Joint Local Impact Report of
Cherwell District Council
Vale of White Horse District Council
West Oxfordshire District Council
Oxfordshire County Council

BOTLEY WEST SOLAR FARM (BWSF) REF: EN010147

June 2025

Illustrative Masterplan Plan 08

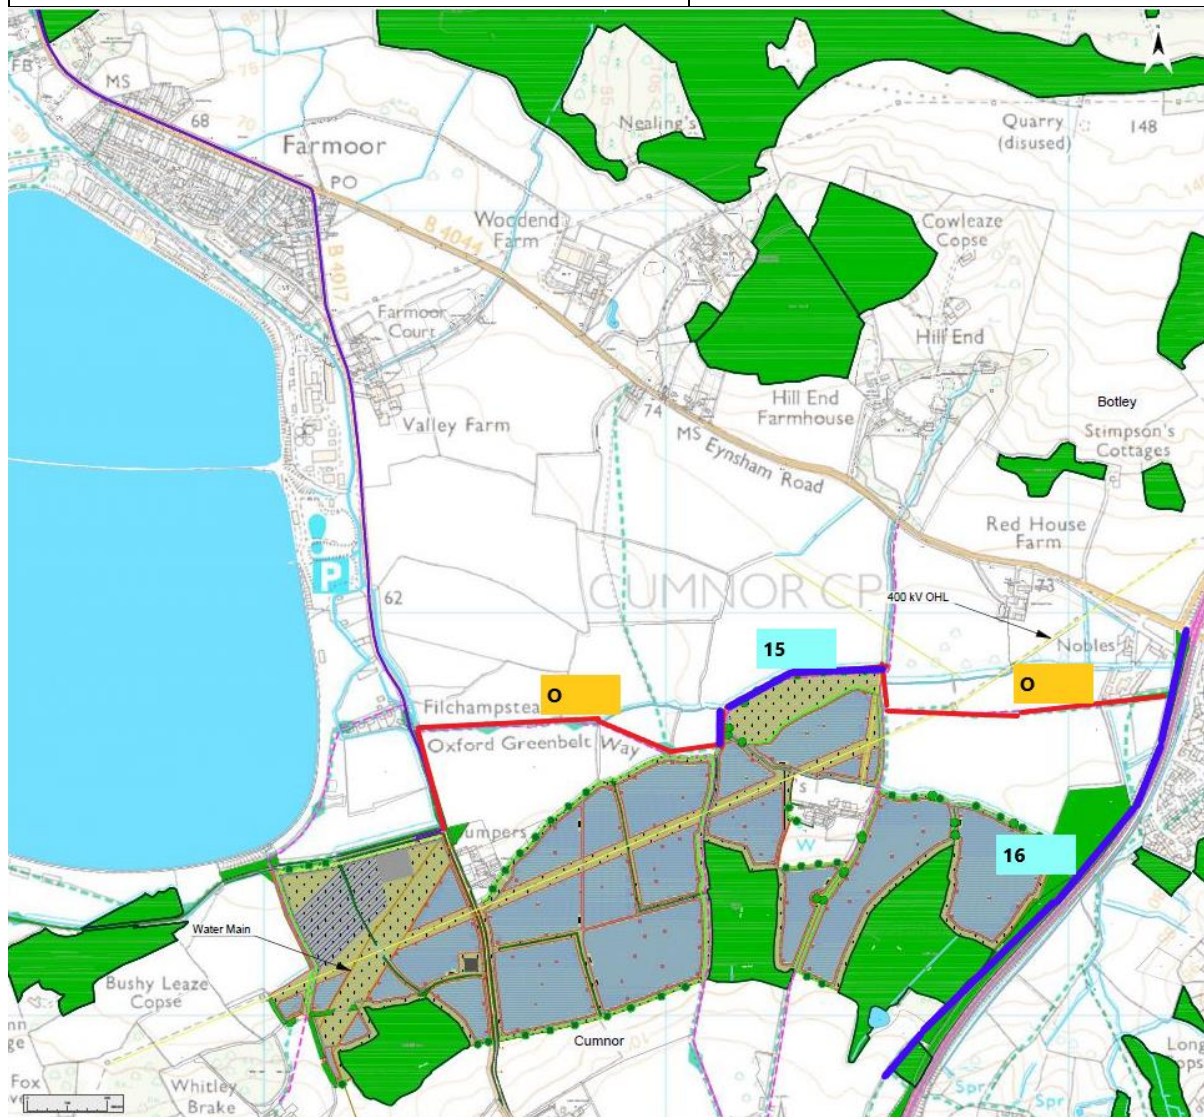
- 15. Upgrade footpath to bridleway
- 16. Link path and upgrade to bridleway

O. Upgrade footpath to bridleway
